ADDENDA – A-01

.1 Bids in accordance with the Drawings and Specifications included with these Bid Documents for:
Fort St. John Hospital – Residential Care Cooling Upgrade.

PROJECT:
**FORT ST. JOHN HOSPITAL
RESIDENTIAL CARE COOLING
UPGRADE**

DRAWING TITLE:
ELECTRICAL PART PLANS

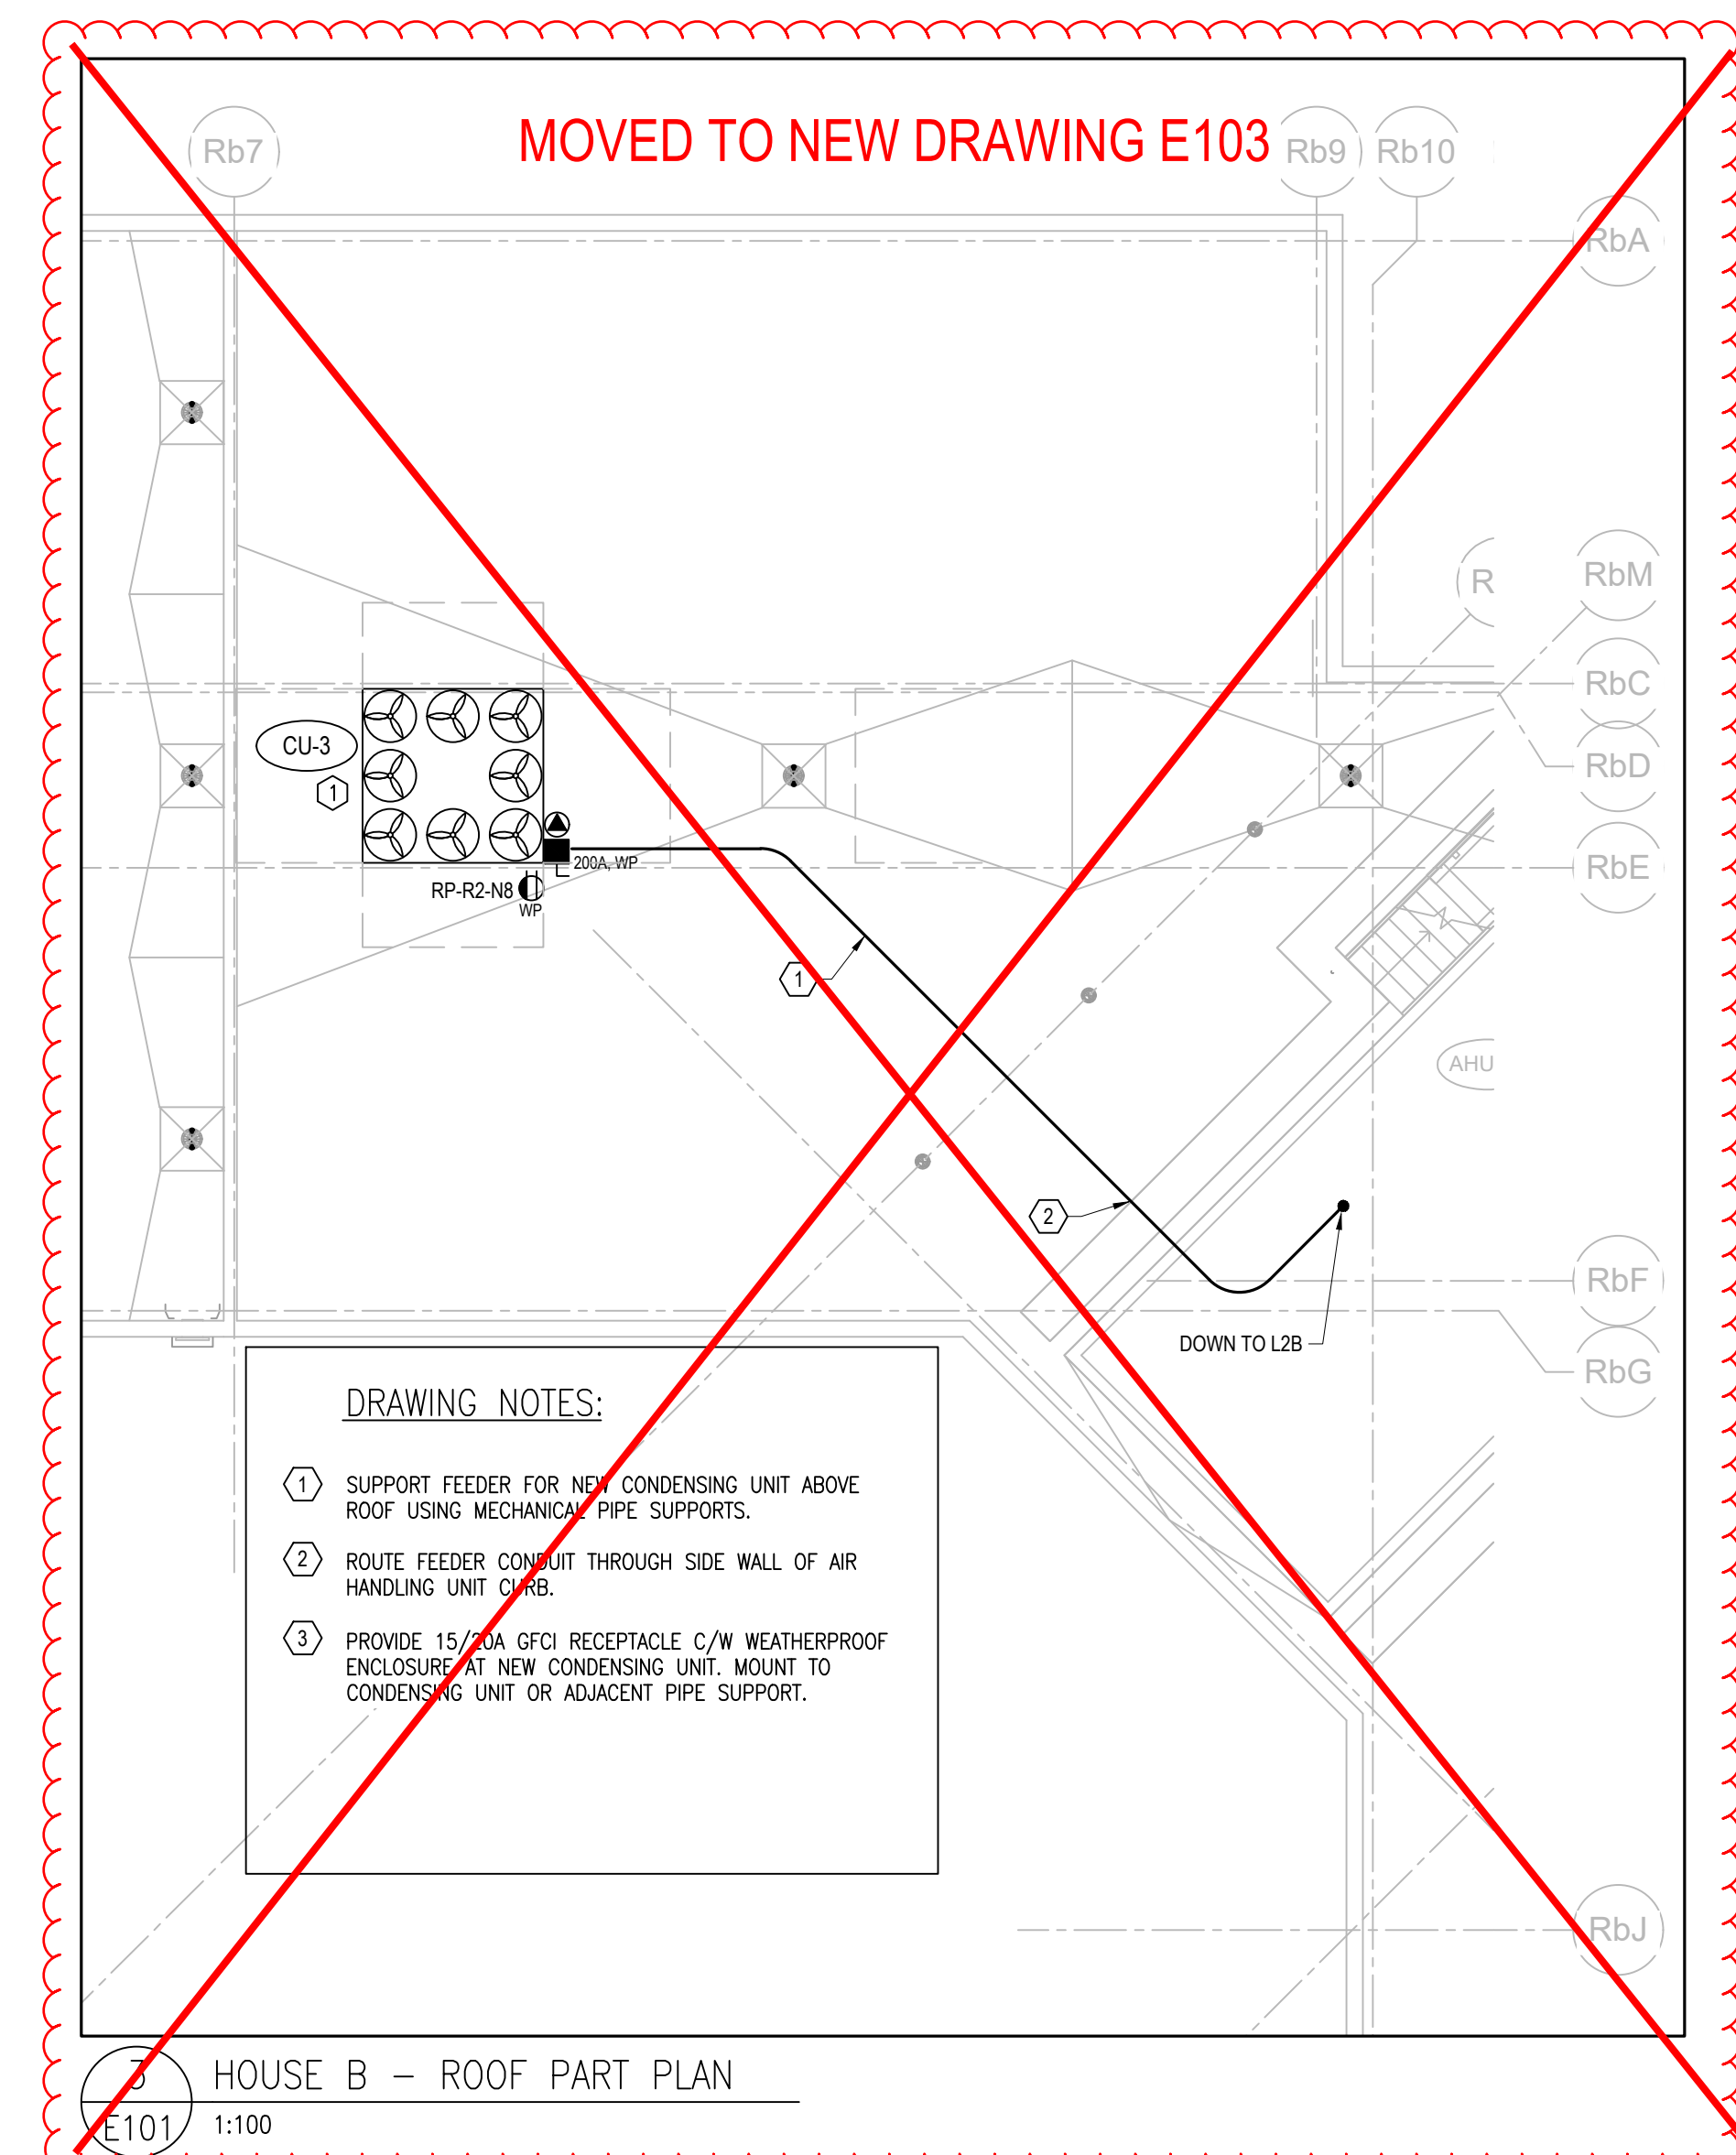
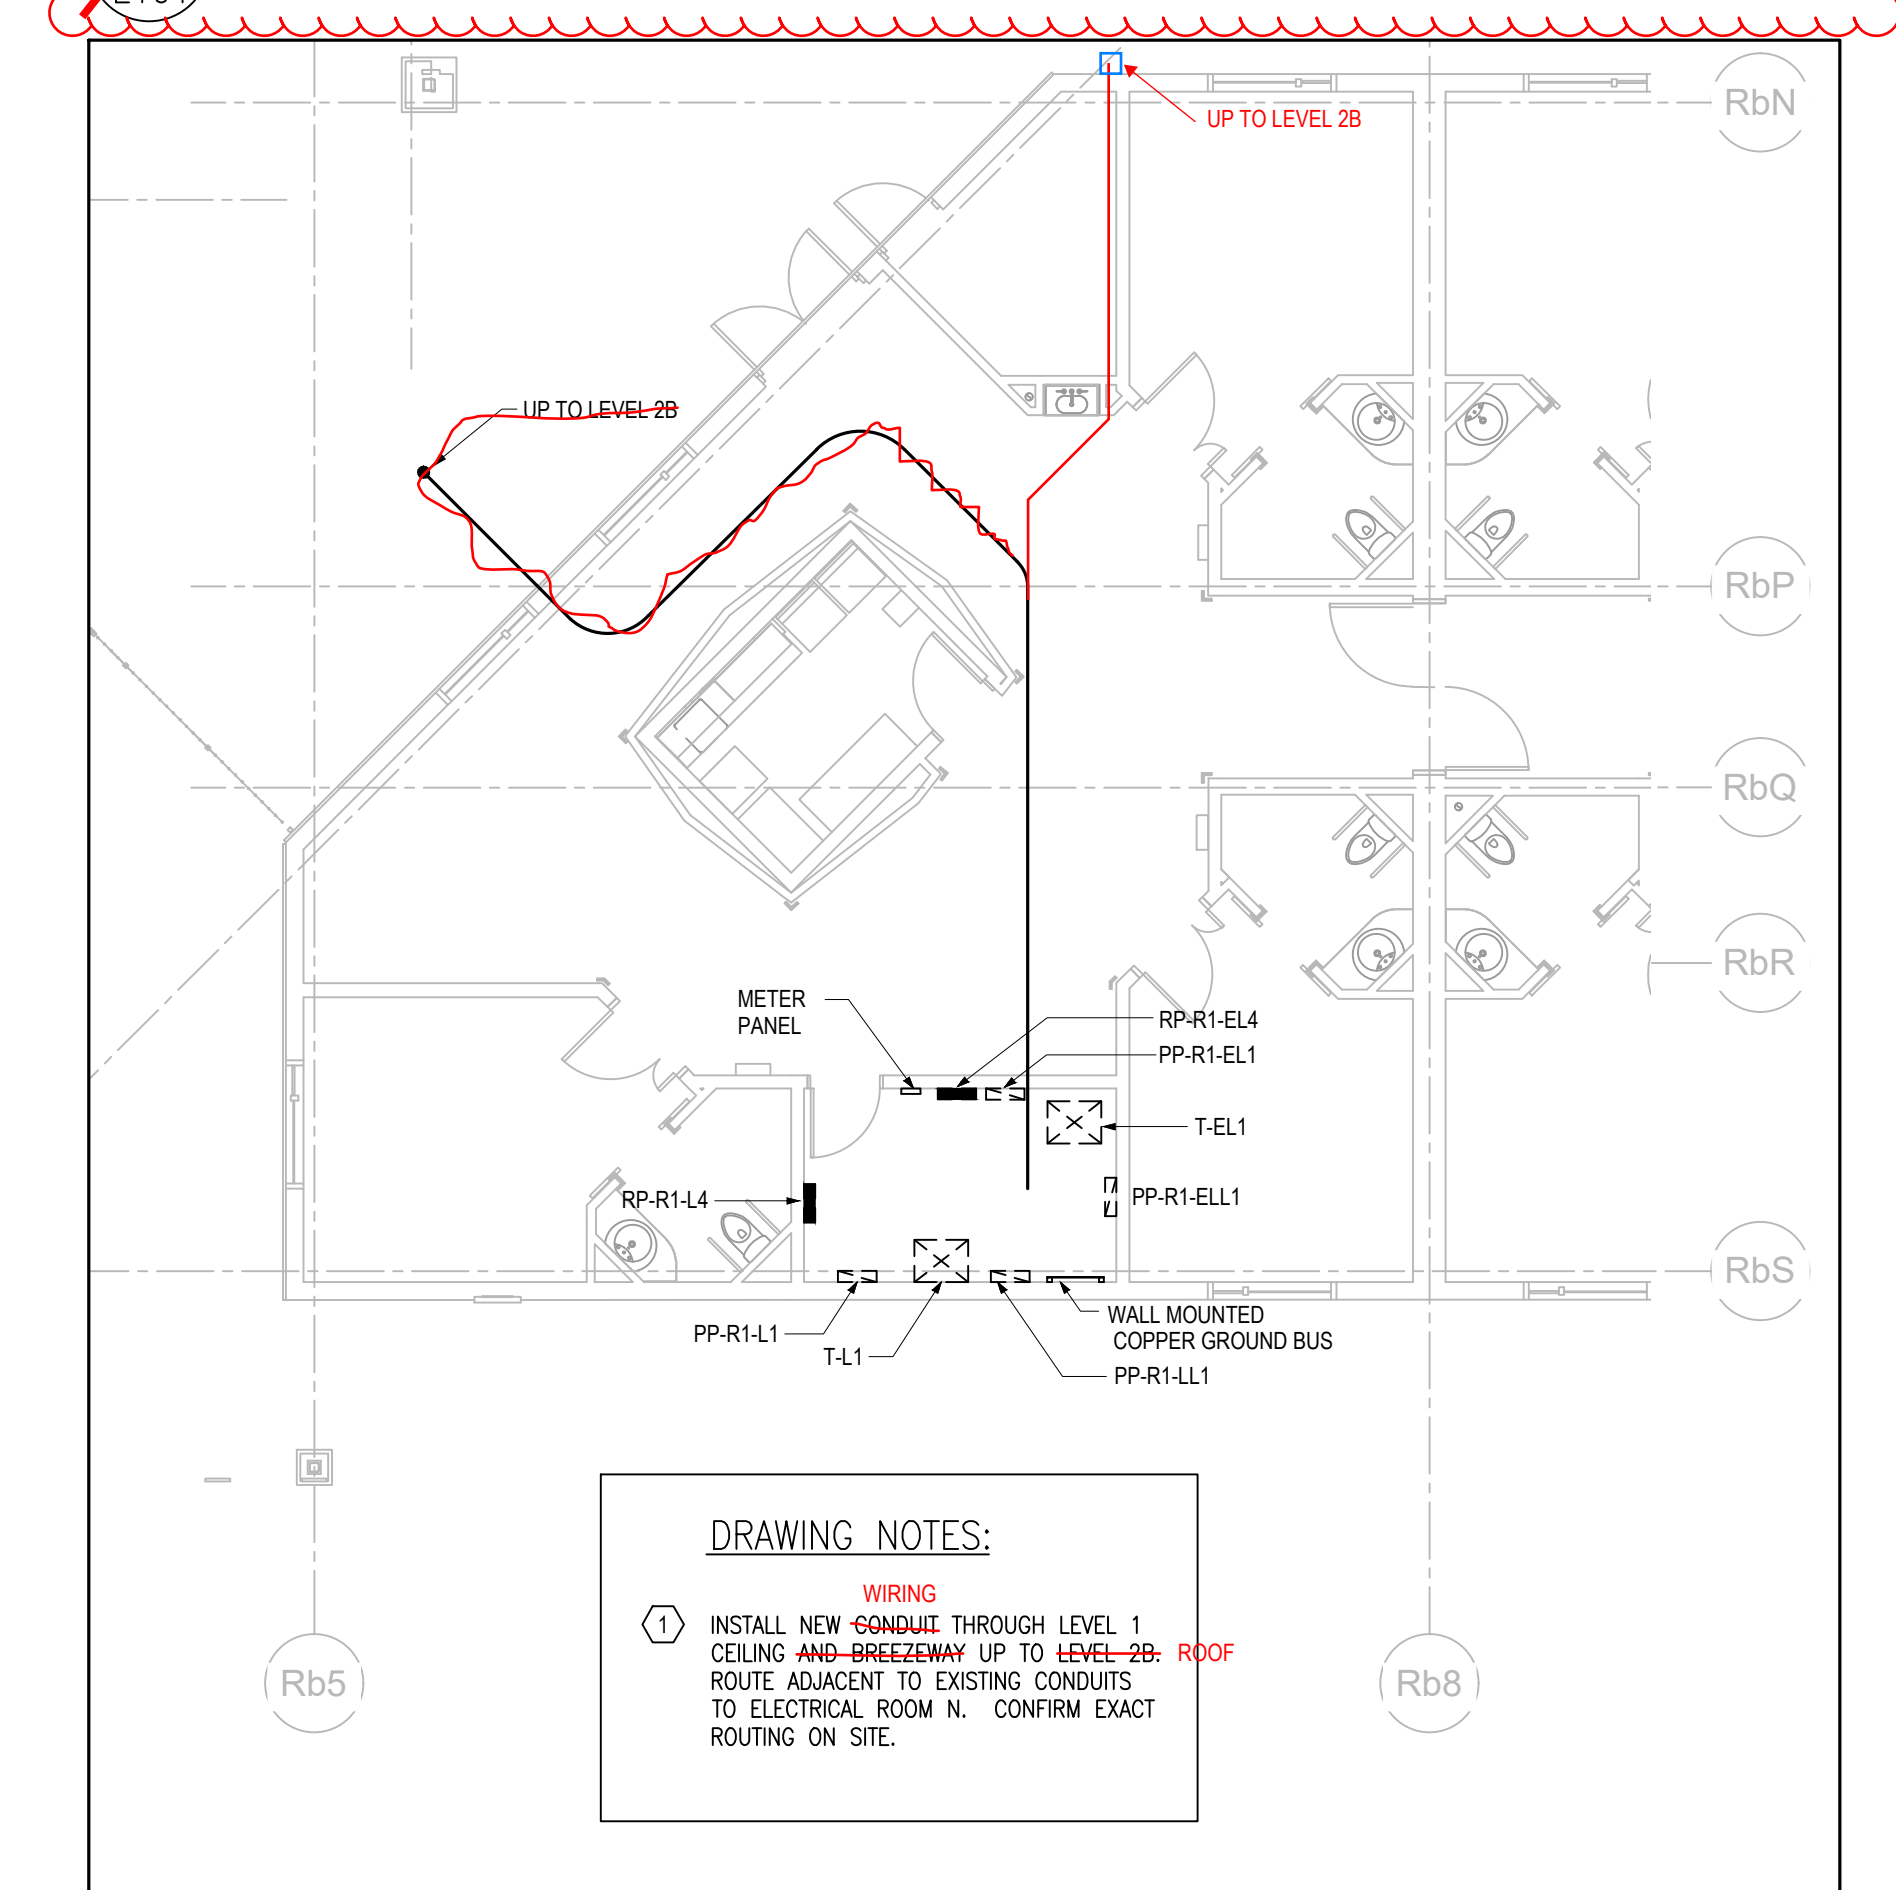
2.5 E101 – ELECTRICAL PART PLANS HOUSE B LEVELS 1, 2B, & ROOF

.1 Revised approach to new wiring approach as shown.

3 ELECTRICAL FEEDER ROUTING**3.1 Description of Revised Approach**

- .1 The electrical feeder routing to the new condenser units in House A and House B has been revised to route exterior to the building, refer to the updated electrical drawings.
- .2 Exterior electrical feeders to be rated for outdoor installation and extreme environments, see “TECK90 – Aluminum Conductor” product datasheet included.
- .3 Exterior electrical feeders to be in an enclosure fastened securely to the building with Hardi plank finishing to match the building and minimize visual impact.
- .4 Electrical feeders shall not be exposed in the courtyard or accessible to patients or visitors in any way.
